NUMBER: 21-015-05

45RFE / 545RFE Trans - Delayed Engagement Due To Cooler Return Filter Replacement

This bulletin involves a transmission delayed shift condition that may occur following the replacement of the internal cooler return filter.

Fig. 1 Transmission Filters - 4X4 Shown

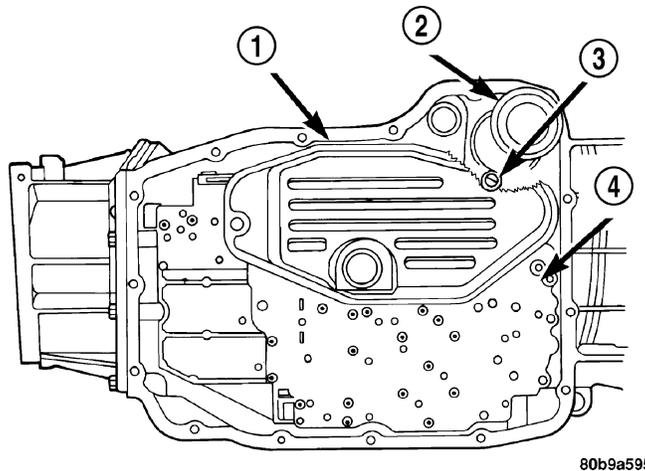
The above condition may be caused by a suspect cooler return filter a part number of **04799662AB**. This “**AB**” suffix / level filter may allow transmission fluid to drain back out of the torque converter. The drain back condition may occur over a period time when the

All 04799662AB cooler return filters with the "AB" suffix are suspect. The above condition may be corrected by replacing a suspect "AB" filter with a new cooler return filter whose part number is 04799662 (with no suffix or with a suffix that is other than the "AB" level).

NOTE: A replacement 04799662 cooler return filter may come packaged with a separate threaded adapter stud. The threaded adapter stud is used to attach the cooler return filter to the transmission. Inspect the stud and note end without threads. Install the stud end without the threads into the cooler return filter and tighten the stud-to-filter connection to 18.6 Nm (165 in. lbs.). Once the threaded adapter stud has been installed to the cooler return filter, install the assembled cooler return filter to the transmission and tighten the filter to 14.1 Nm (125 in. lbs.)
